ADDENDUM NO. 1 - OUTLINE AND SUMMARY INFORMATION

Project Name: Renne Library Data Center UPS Replacements

PPA No.: 24-1182

Location: Montana State University - Bozeman

EPO WIRING DIAGRAM FOR RENNE ITC

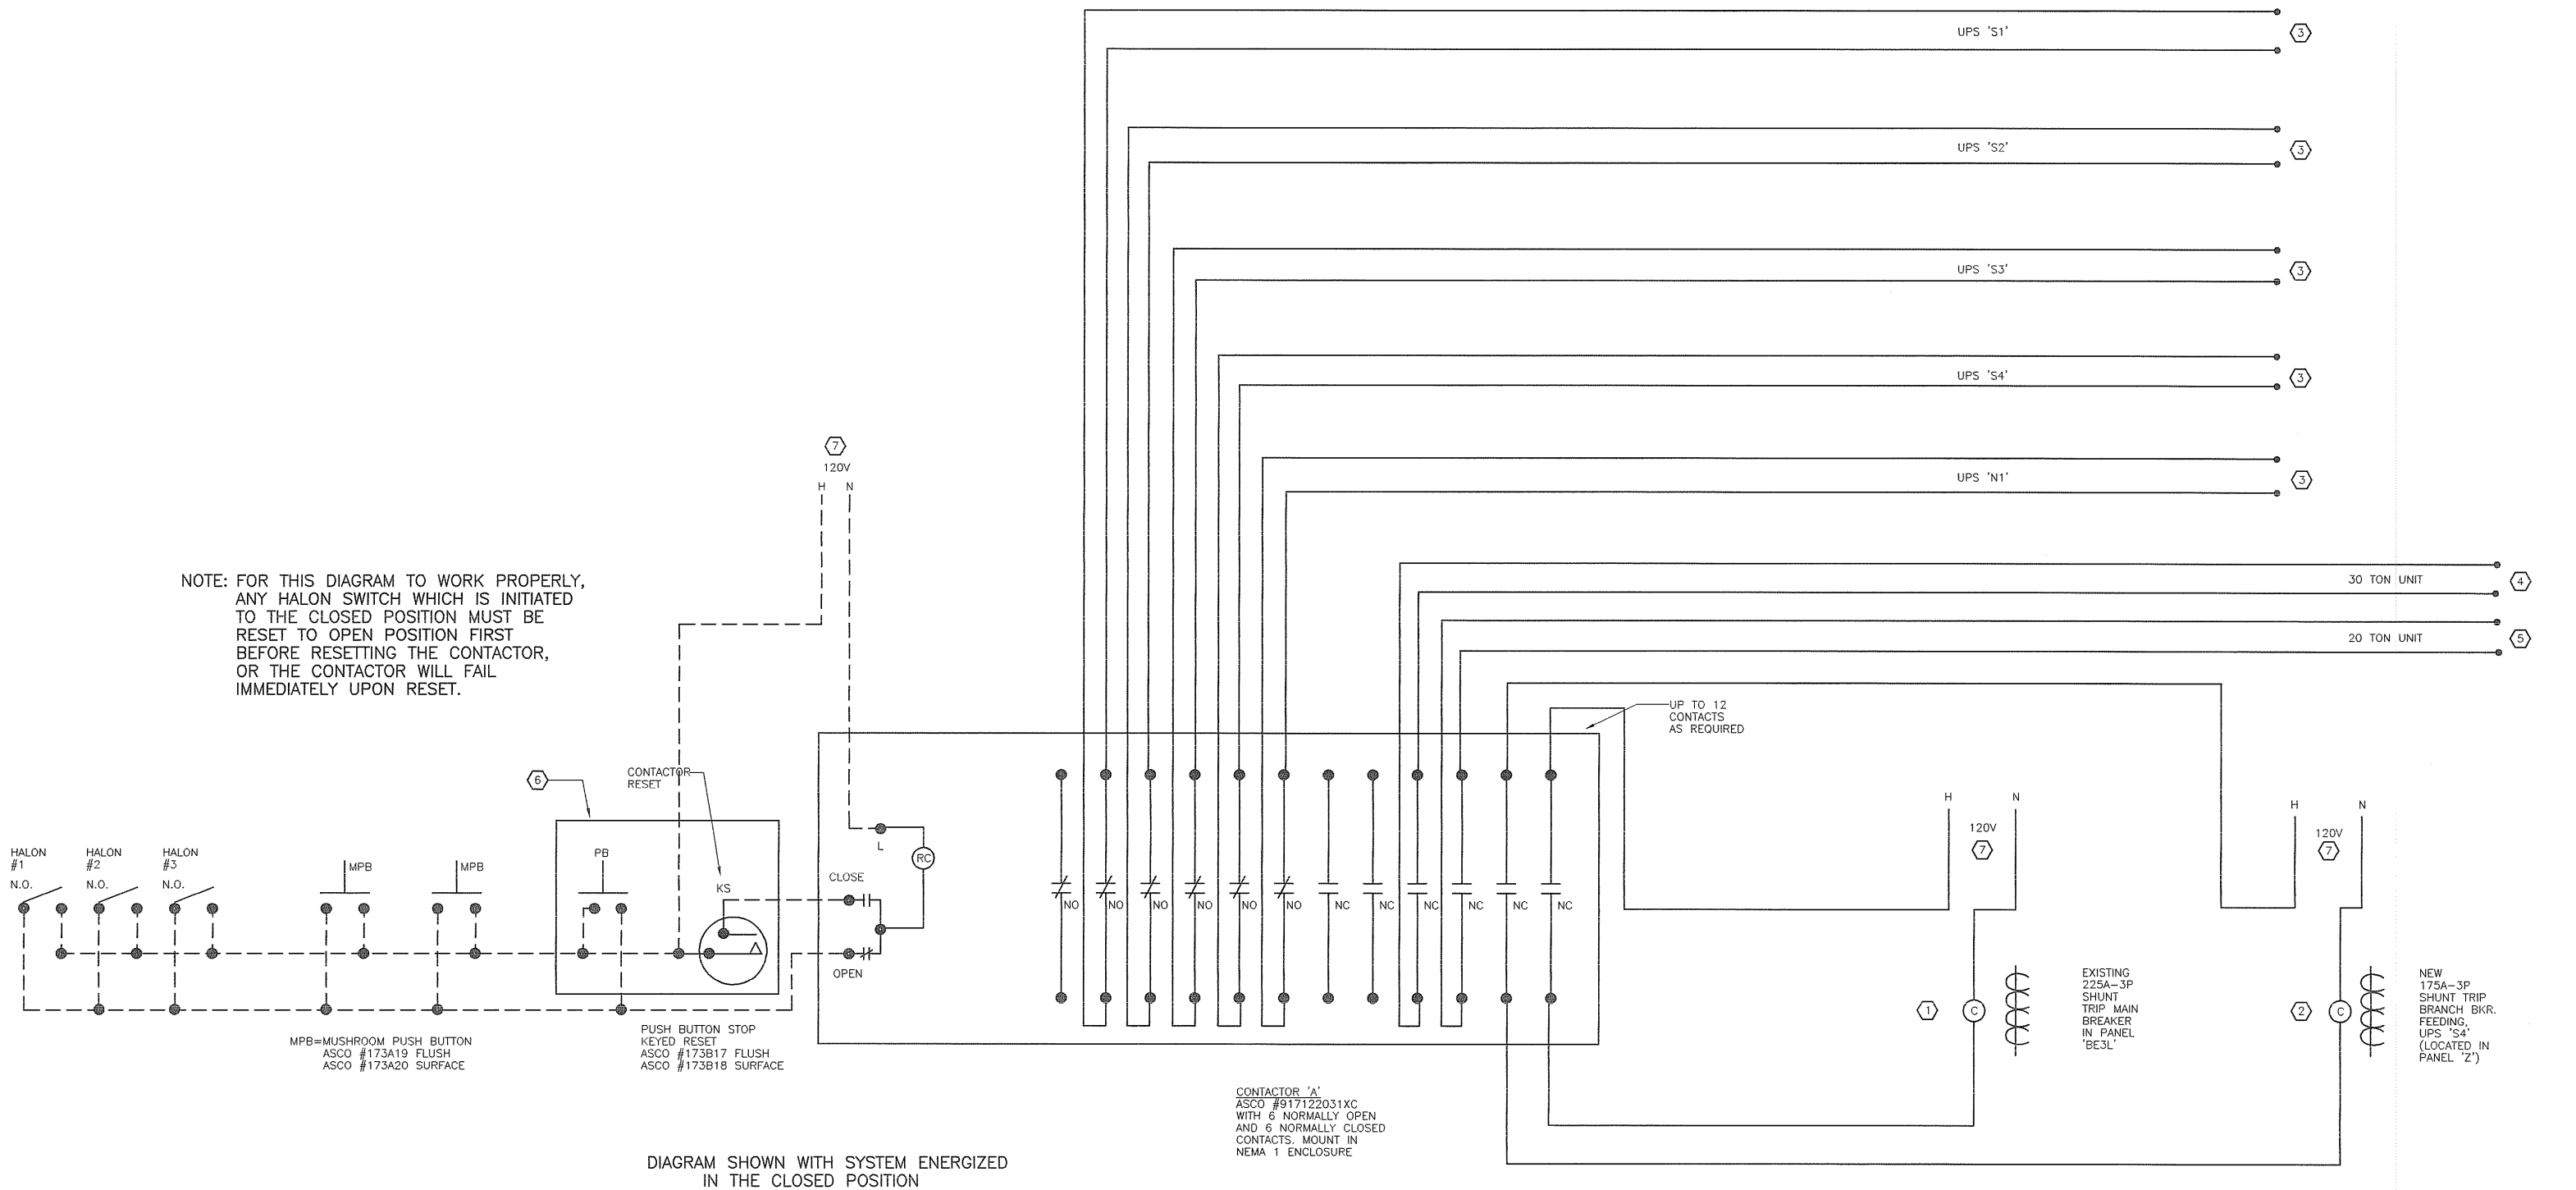
- a. SHEET E2, Specific Sheet Note 1 – **CLARIFICATION:** Remove all unused wiring from emergency shut-down contactor associated with existing EPO pushbuttons. Refer to attached wiring diagram. When project is finished, EPO's and associated contactor shall initiate shutdown of UPS-A, UPS-B (or S4 if alternate is not accepted), and existing HVAC units. All other conduit and wiring associated with old UPS's, circuit breakers, and defunct halon system shall be removed and labeling shall be updated. Additionally, remove control station associated with old halon system. Note that when testing EPO's and associated contactor with new UPS during startup and commissioning, the other UPS and HVAC units shall be disconnected so that they do not shut down accidentally. All testing of EPO's must be preauthorized and under the direct supervision of the engineer and MSU UIT.
